SERVICE INFORMATION LETTER

SERVICE INFORMATION LETTER INDEX

SUBSIDIARY OF ISRAEL AIRCRAFT INDUSTRIES. LTD.
BEN GURION AIRPORT, ISRAEL

FIGURE 3

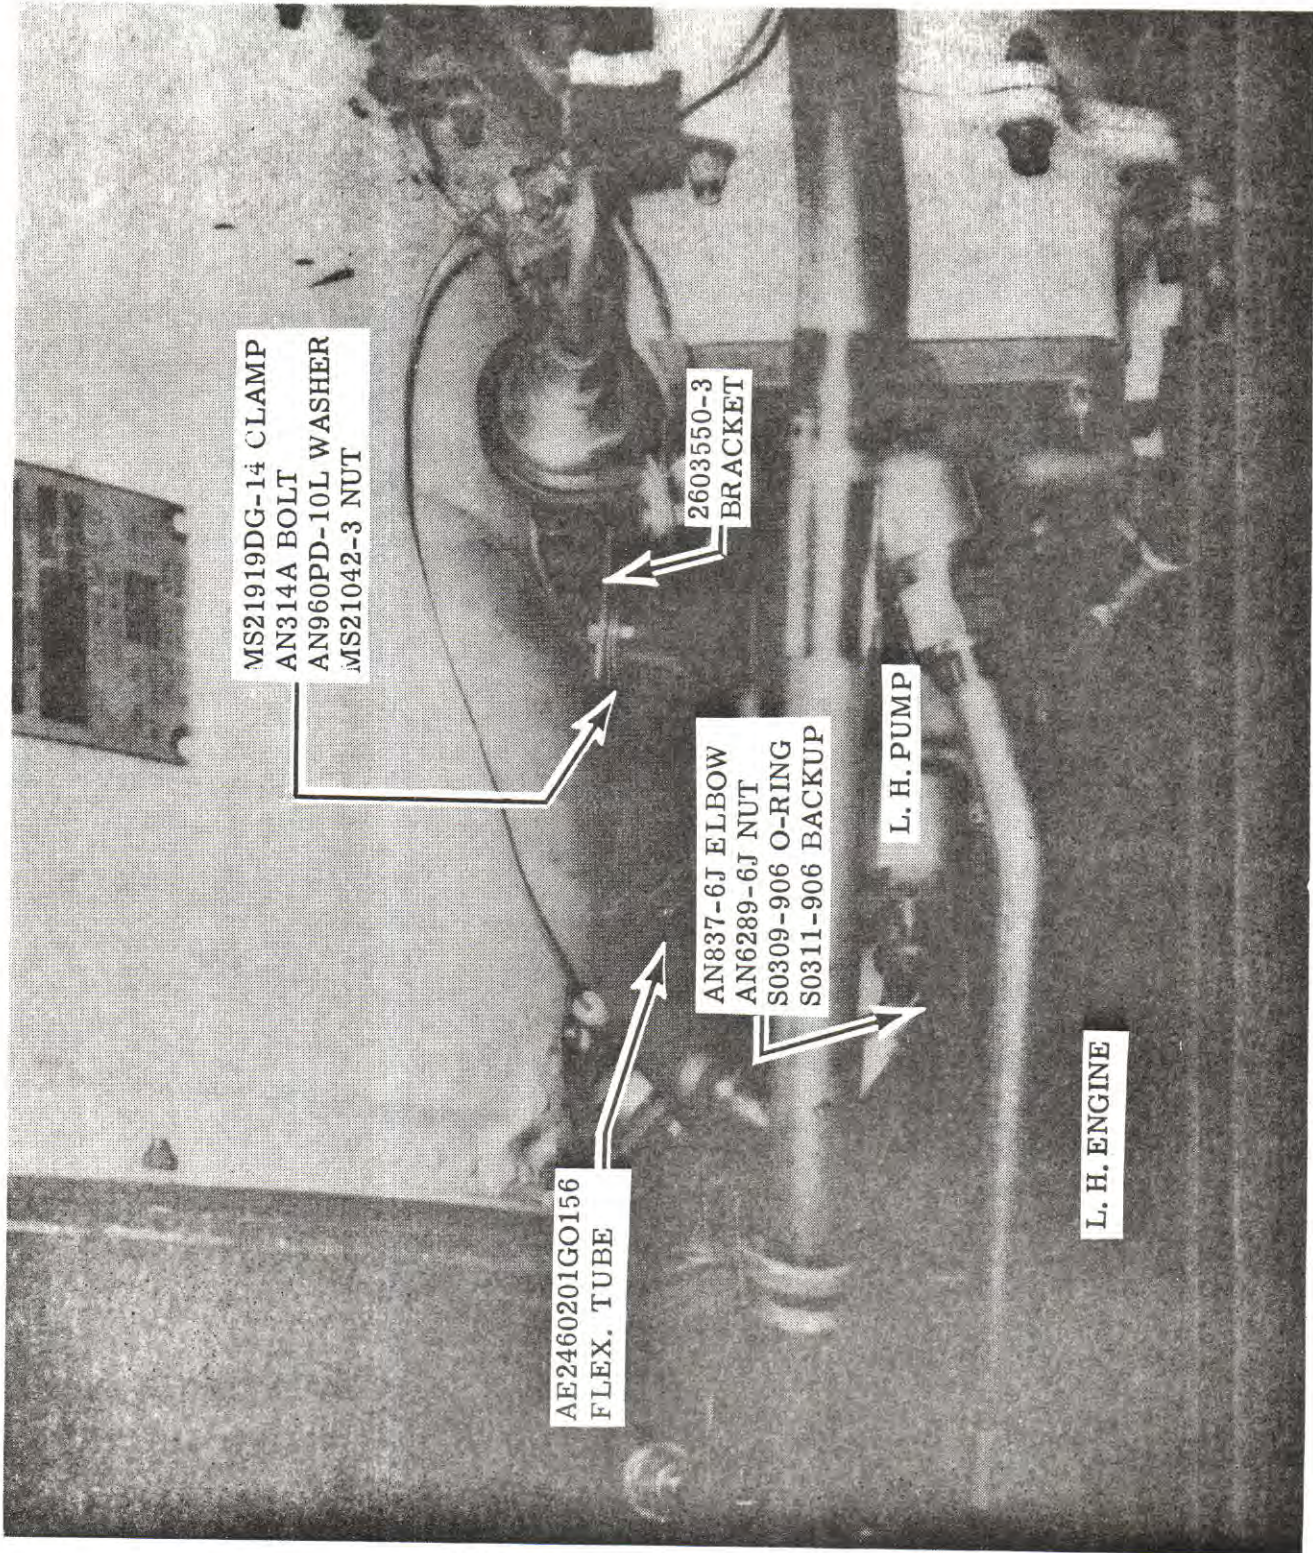
19. Install new tube P/N 3603548-7 between outlet port of fitting P/N 4713560-501 and quick disconnect fitting, per Figure 3.
20. Refer to Figure 6 and install a sleeve P/N 3713561-501, attenuator P/N 3713562-1, with a S0309-910 O-ring on each accessory drive pad fitting P/N 4713560-501. Torque and safety wire attenuators, per Figure 3.

FIGURE 1

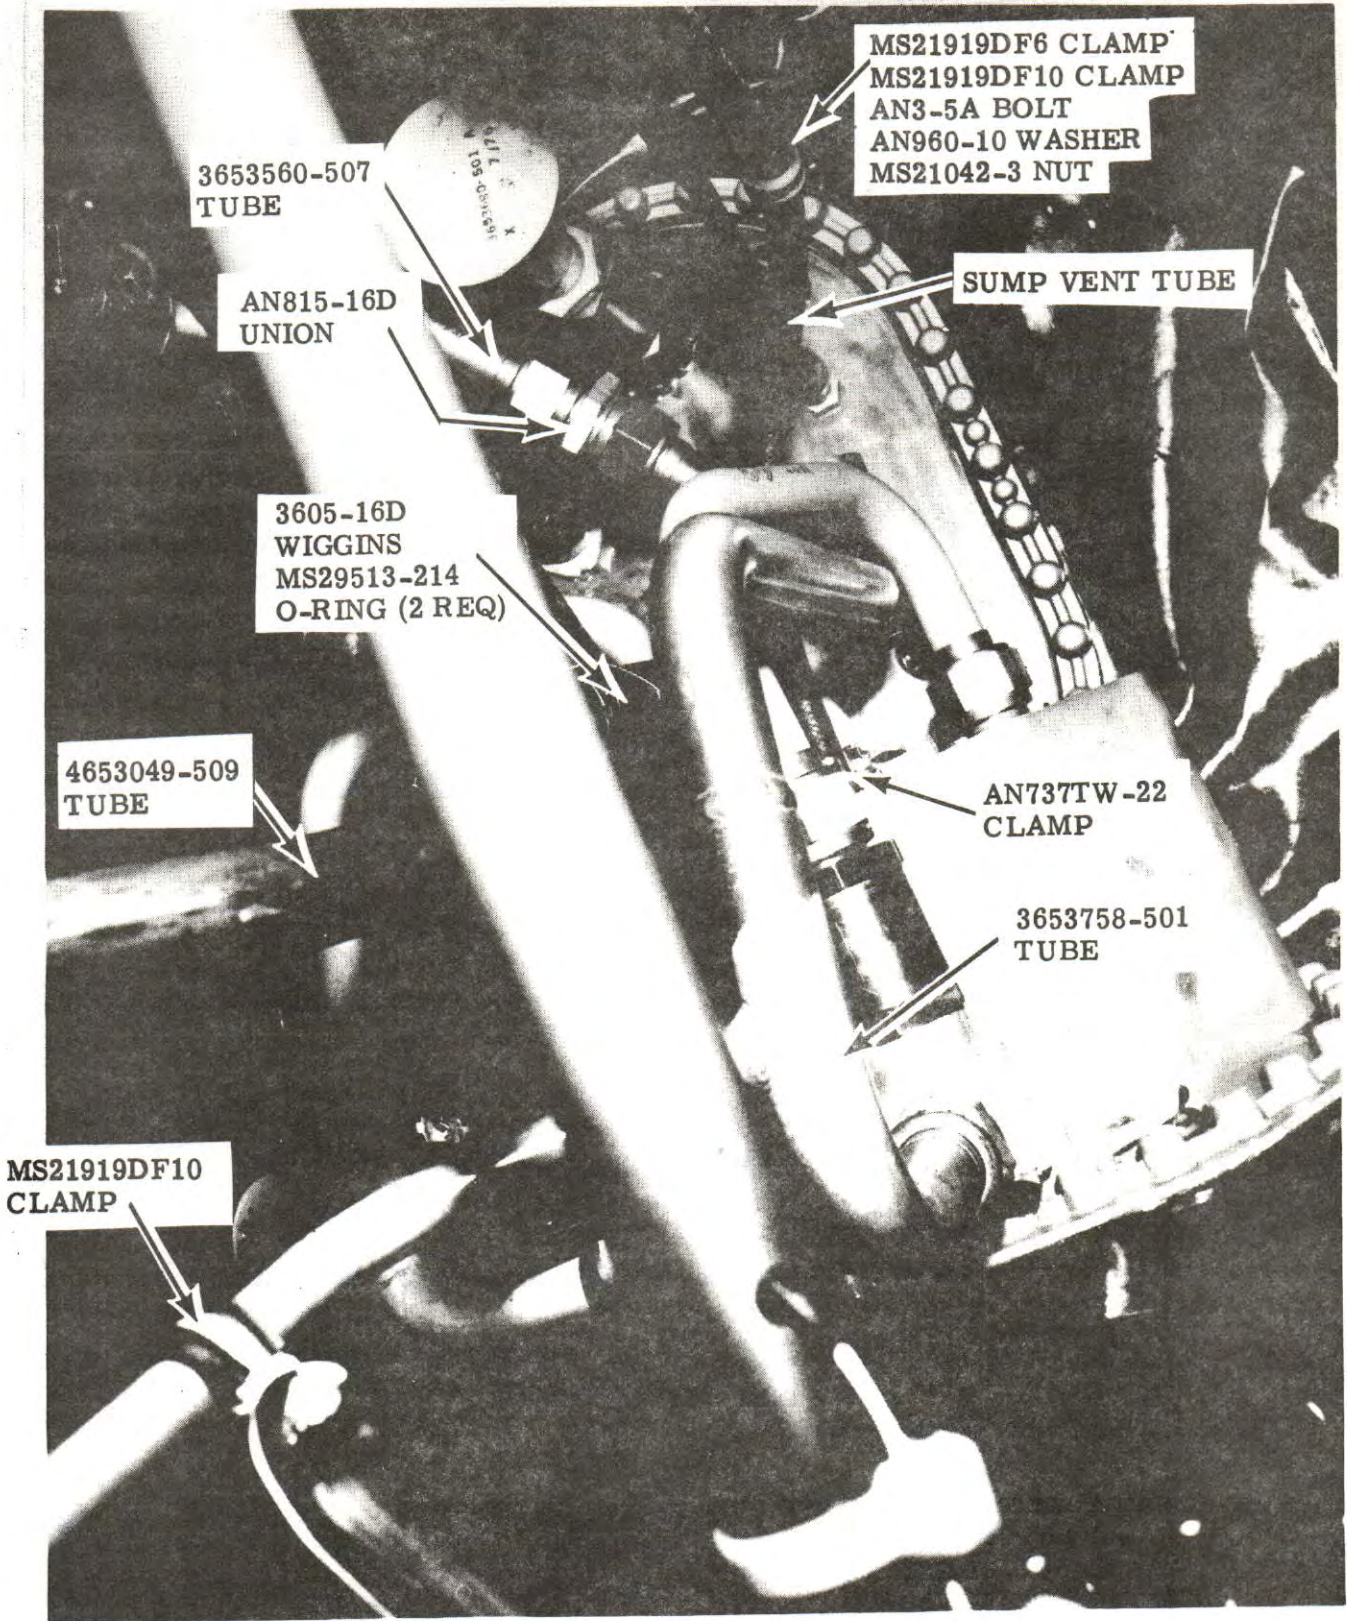
2. Assemble and install the fuel sumps as follows: (Refer to Figure 1).
 - A. Install a 3653741-1 tube in each lower sump casing P/N 5653722-1-51 and 5653722-2-51 using a 4653743-505 gasket between tube flange and sump casing.

6. Refer to Figure 1 and install the boost pumps as follows:

LH FUEL SUMP
FIGURE 1A

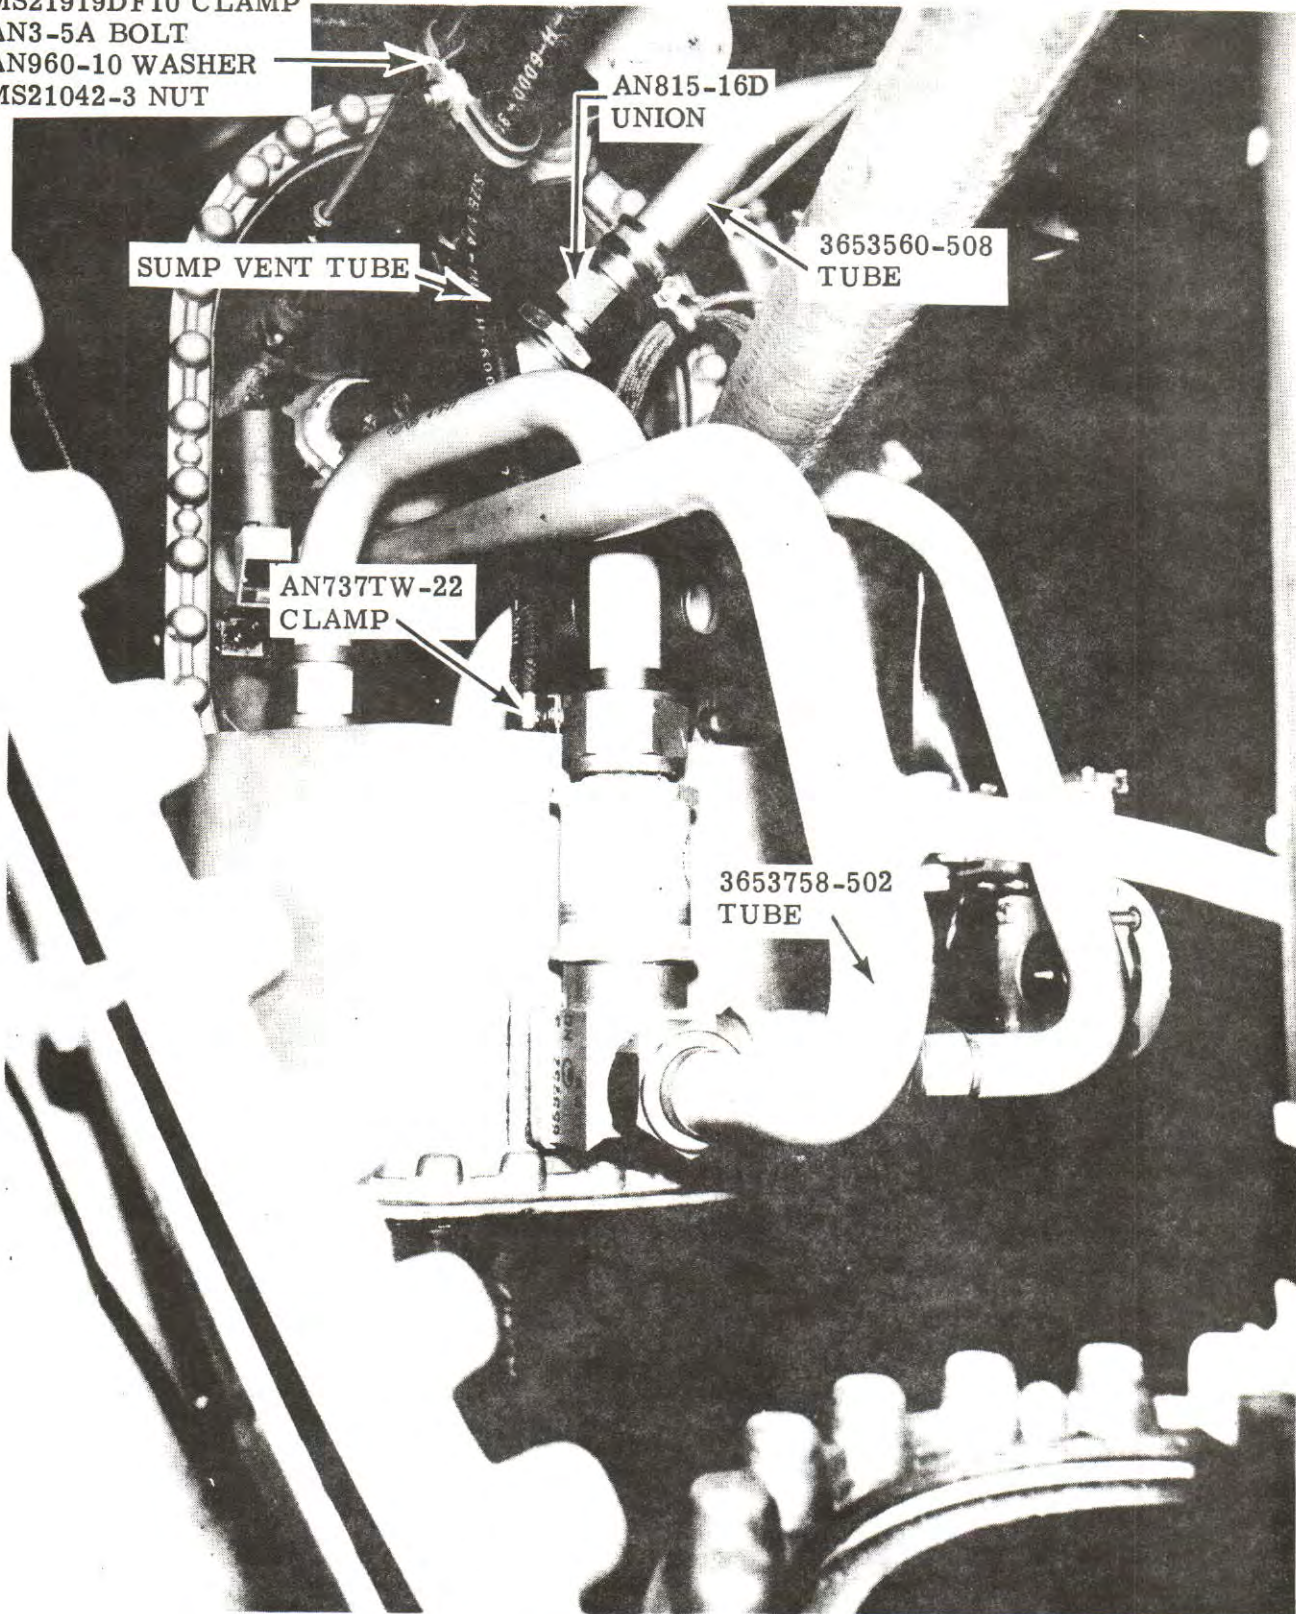
4. Refer to Figure 1A and install tubing as follows:
- A. Install LH transfer valve motive flow tubes P/N's 3653758-501 and 3653560-507 between sump cross fitting and transfer valve, interconnect tubes with an AN815-16D union. Mark flange of 3653560-507 motive flow tube to match holes in transfer valve mount bracket. Remove tube and drill mounting holes, using a No. 10 drill. Reinstall transfer valve (previously removed in Part A, Step 8D) and motive flow tube, using 2 each new gaskets P/N 5653054-531 and attaching hardware. Safety wire attaching bolts.

FILTER BRACKET ASSY. INSTALLATION
FIGURE 2

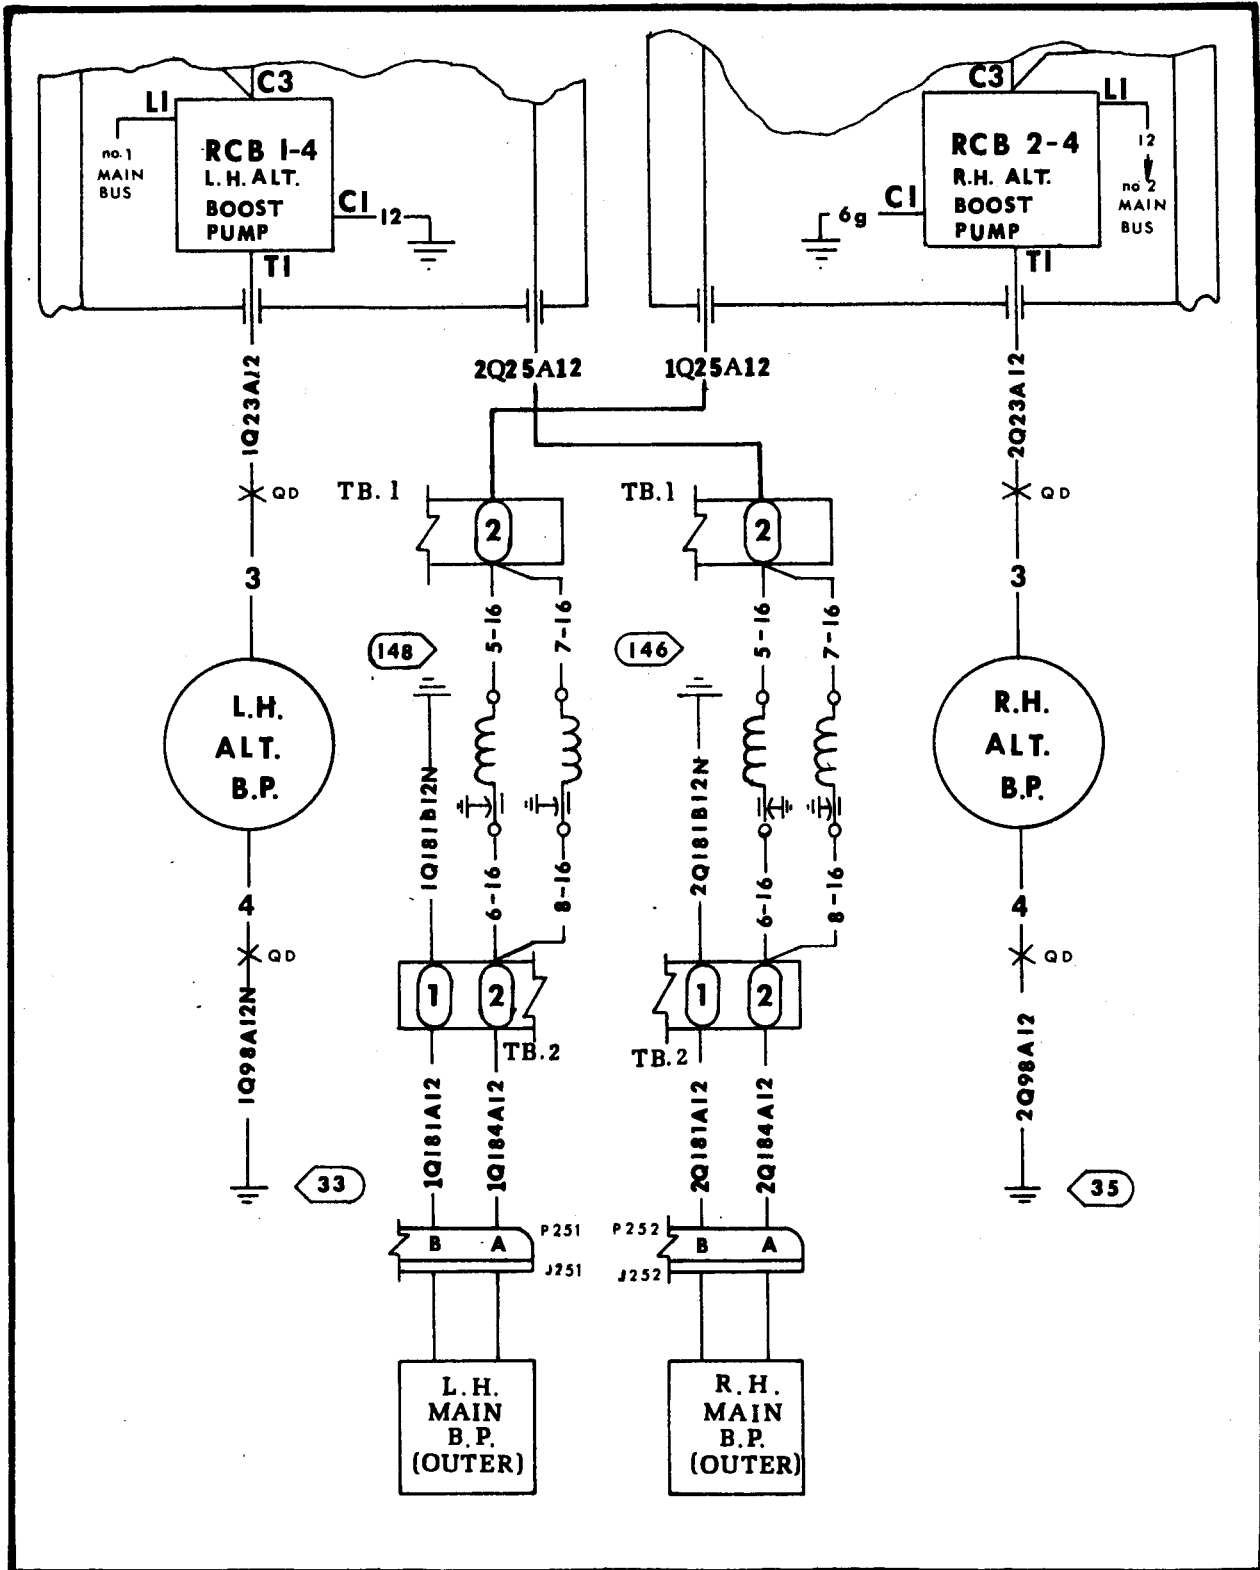
8. Refer to Figure 2 and Figure 2A and install boost pump filter and electrical connections as follows:
- A. Locate and drill holes in lower frame Sta. Y306.95, LH and RH. Remove sufficient paint around holes to provide electrical ground. Mark ground point holes. Install MS21266-IN grommets in appropriate holes.
 - B. Install LH and RH filter bracket assemblies P/N 5823668-3-405, secure with 4 each MS35206-245 screws and AN960PD8 washers. Check bonding for maximum 0.0025 OHMS between frame and filters.
